**Proposed Residential Development at Area 106B, Tung Chung, TCTL No. 55
Section 16 Planning Application for Proposed Minor Relaxation of Maximum Building
Height Restriction for Permitted Flat Use in "Residential (Group B) 3" Zone
(Application No. A/I-TCE/7)**

Responses to Comments Table

Figure 4: Additional Greenery Provision within Development Site Area

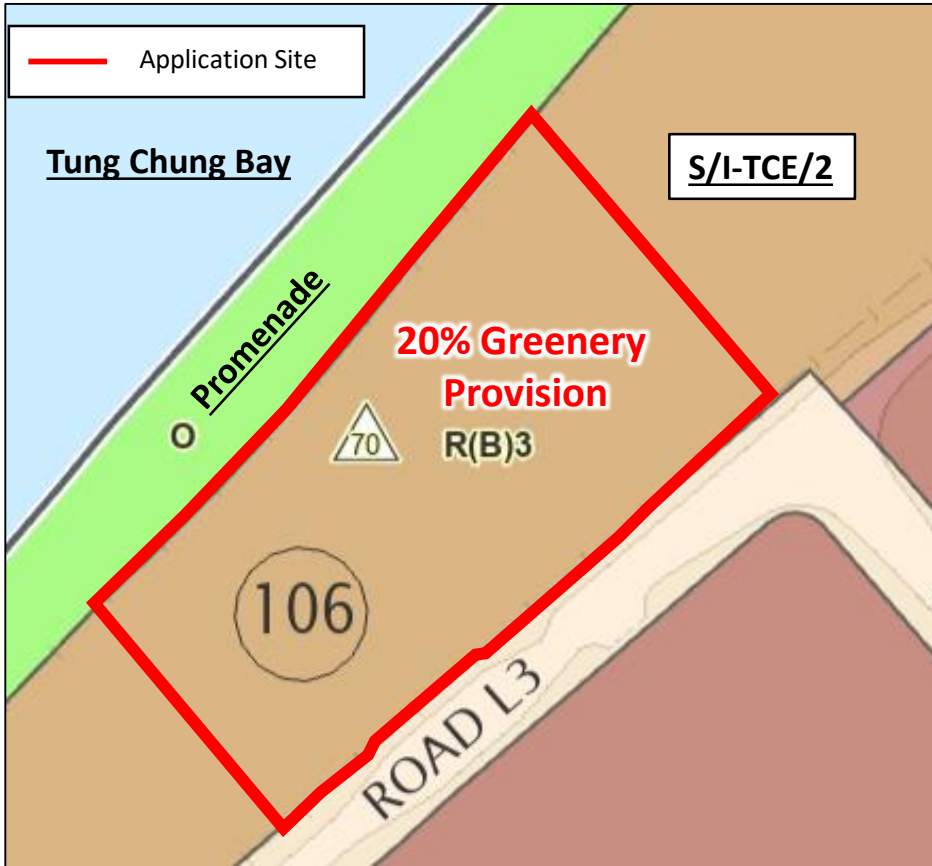
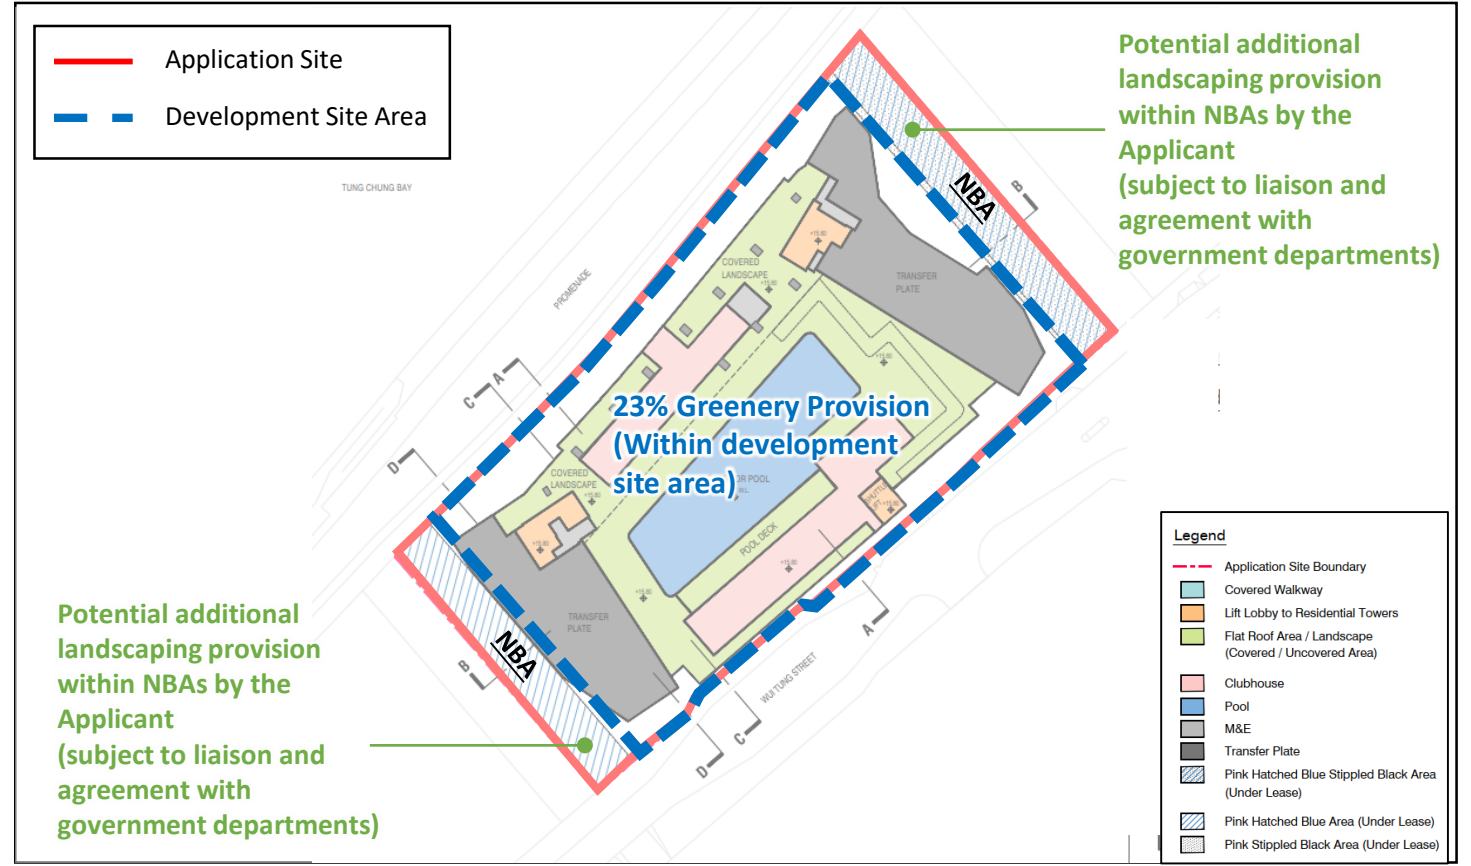
Departmental Comments	Responses to Comments
1.2 (Con't)		<p>For greenery provision, in accordance with the requirement of the Sustainable Building Design Guidelines (PNAP APP-152), the overall minimum site coverage of greenery required for the entire Application Site is 20%.</p> <p>Given that the two strips of non-building area (NBA) along the northeastern and southwestern boundary will be surrendered back to the Government, in order not to reduce the overall greenery provision for the Application Site, the Applicant has distributed all the proposed greenery within the development site area (i.e. area outside NBAs). The greenery provision within the development site area is therefore able to achieve a coverage of not less than 23%. Besides, according to the lease, the Applicant will also need to provide landscaping provision within the two NBAs, subject to liaison and agreement with relevant government departments at detailed design stage. In turn, the two strips of NBAs might be able to provide additional greenery provision on top of those within the development site area, which will further enhance the streetscape of the Application Site.</p> <p>Please also refer to the revised set of drawings, development schedule and supplementary drawings for the Proposed Scheme in Attachments 2 and 3 for details.</p>

- In accordance with the requirement of the Sustainable Building Design Guidelines (PNAP APP-152), the overall minimum site coverage of greenery required for the entire Application Site is 20% (i.e. area within the red line).

- Given that the two strips of non-building area (NBA) along the northeastern and southwestern boundary will be surrendered back to the Government, in order not to reduce the overall greenery provision for the Application Site, the Applicant has distributed all the proposed greenery within the development site area (i.e. demarcated in blue dotted line). The greenery provision within the development site area is therefore able to achieve a coverage of not less than 23%.
- Besides, according to the lease, the Applicant will also need to provide landscaping provision within the two NBAs, subject to liaison and agreement with relevant government departments at detailed design stage. In turn, the two strips of NBAs might be able to provide additional greenery provision on top of those within the development site area, which will further enhance the streetscape of the Application Site.

Figure 5: Carparking Extent Being Minimal to Minimise Building Bulk

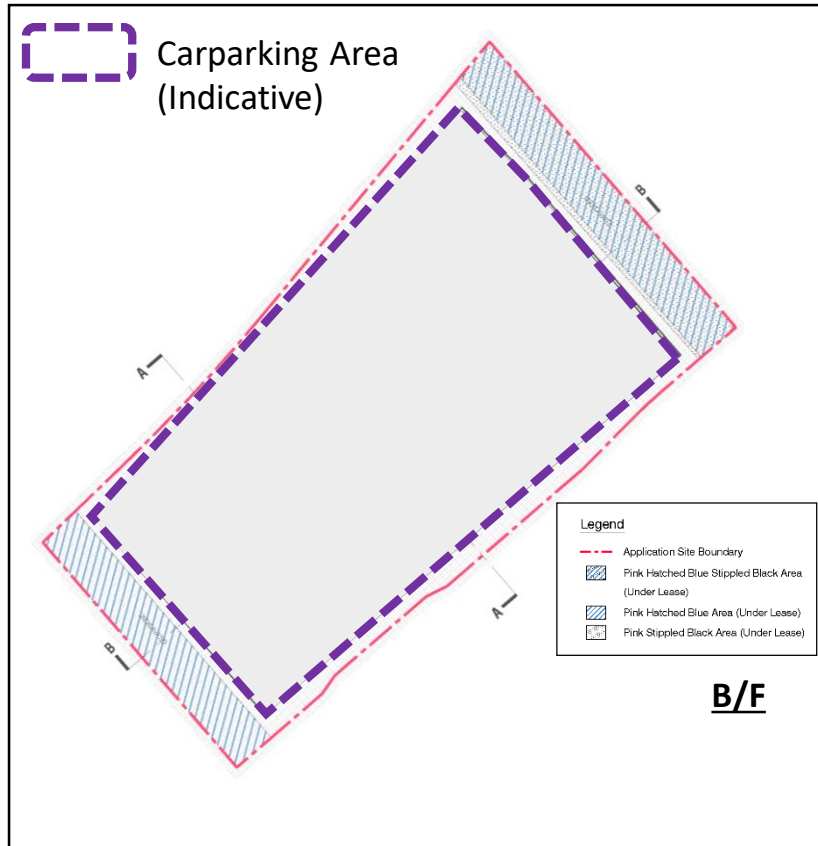
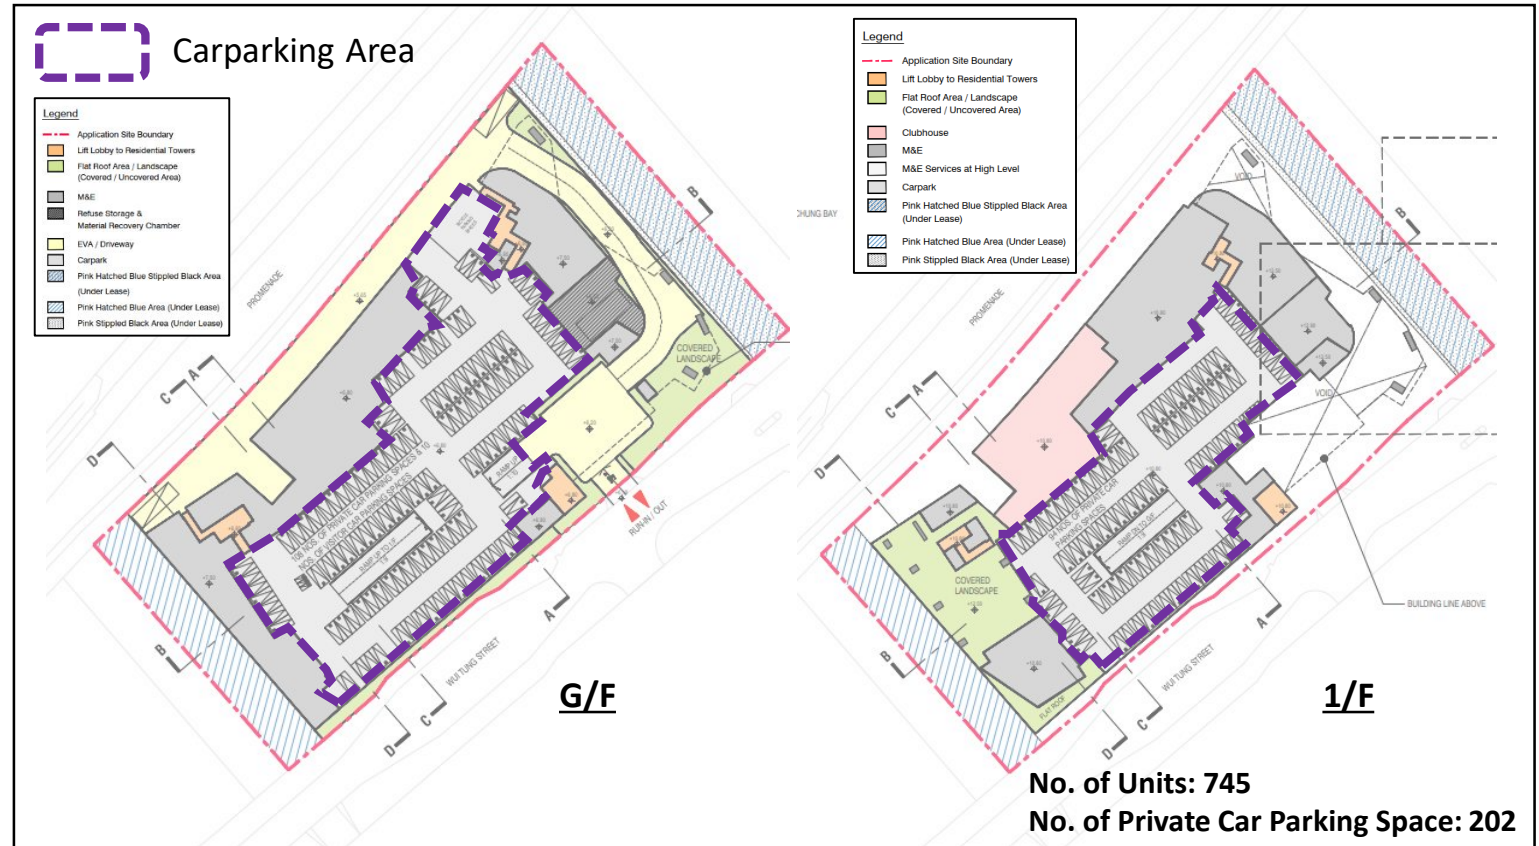
1.4	<p>Please provide compelling justifications for the 50% increase in no. of storeys for the proposed car parking provision, given that this scheme maintains largely the same no. of parking spaces (i.e. a total of 202 car parking spaces).</p>	<p>Please note that, with basement carpark design, apart from avoiding encroachment into the two NBAs and unexcavated areas reserved along the site boundaries, the area available for the floor plate of carparking area could cover majority of the Application Site. However, for the Proposed Scheme with above ground carpark design, the area available for carpark is constrained by other provisions above ground, such as the necessary EVA arrangement for firefighting, ingress/egress points, etc. These facilities would not be provided at basement level. As a result, it is not feasible to accommodate all of the 202 nos. of carparking spaces on a single floor (i.e. G/F). Therefore, some of the required carparking spaces would have to be accommodated on another floor (i.e. 1/F). Accordingly, a 2-storey above ground carpark is required for the Proposed Scheme.</p> <p>Please also refer to the revised set of drawings, development schedule and supplementary drawings for the Proposed Scheme in Attachments 2 and 3 for details.</p>

- Number of car parking provision [based on the carparking ratio stipulated under Lease.](#)
- With basement carpark design, [apart from the NBAs and unexcavated areas reserved along site boundaries, the floor plate available for carpark could cover majority of the Application Site.](#)

- For the Proposed Scheme with carpark relocated above ground, [after taking into account the necessary EVA arrangement, ingress/egress points, etc., it is **not** feasible to accommodate all the car parking spaces on a single floor \(i.e. G/F\). Some of the required car parking spaces have to be accommodated on another floor \(i.e. 1/F\).](#)

- As shown in the above illustrative diagrams with detailed indicative carparking layout, the [maneuvering space provided in the carparking areas under the Proposed Scheme \(in 2 levels\) is reasonable. No excessive parking area is created to raise the building height.](#)

Figure 10: Proposed Site Formation Level Being Reasonable

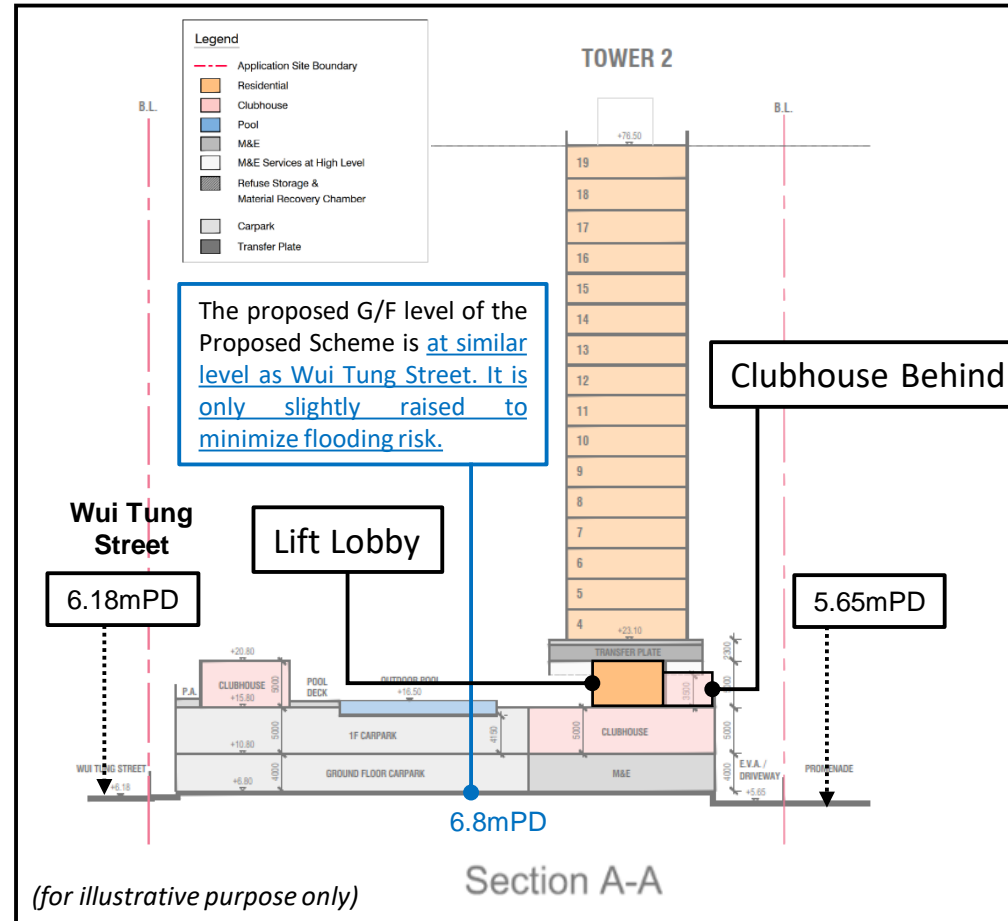
1.6	The existing site formation level of the site is about +5.4mPD to +5.7mPD. According to the submitted floor plans, the proposed site formation level at G/F (i.e. +7.2mPD) exceeds the existing site formation level for the residential development. Please clarify how the proposed site formation level of +7.2mPD (including the site formation levels for the carparking floor and EVA/driveway) is technically justified from an engineering perspective.	<p>The Application Site is located at a waterfront location. In view of the extreme weather condition Hong Kong experienced in the recent years, minimising flood risk is one of the major concerns when formulating the Proposed Scheme. According to the 50-year storm with climate change projected to the end of 21st Century, the flood level of the Tung Chung area is about 5.99mPD (based on the nearest Shek Pik Tide gauge). To also tie in with the street level of Wui Tung Street at 6.18mPD, which is also the ingress/egress point of the Application Site, a reasonable site formation level of 6.8mPD is proposed.</p> <p>As compared with the original scheme submitted to the Town Planning Board in January 2026, the site formation level has been reduced from 7.2mPD to 6.8mPD.</p> <p>Please also refer to the revised set of drawings, development schedule and supplementary drawings for the Proposed Scheme in Attachments 2 and 3 for details.</p>

- The proposed site formation level of 6.8mPD is [to mainly tie in with the street level of Wui Tung Street at 6.18mPD which is the ingress/egress point of the site.](#)
- According to the 50-year storm with climate change projected to the end of 21st Century, the flood level of the Tung Chung area is about 5.99mPD (based on the nearest Shek Pik Tide-gauge). [The proposed G/F level of 6.8mPD is slightly raised to minimize flood risk within the Application Site.](#)
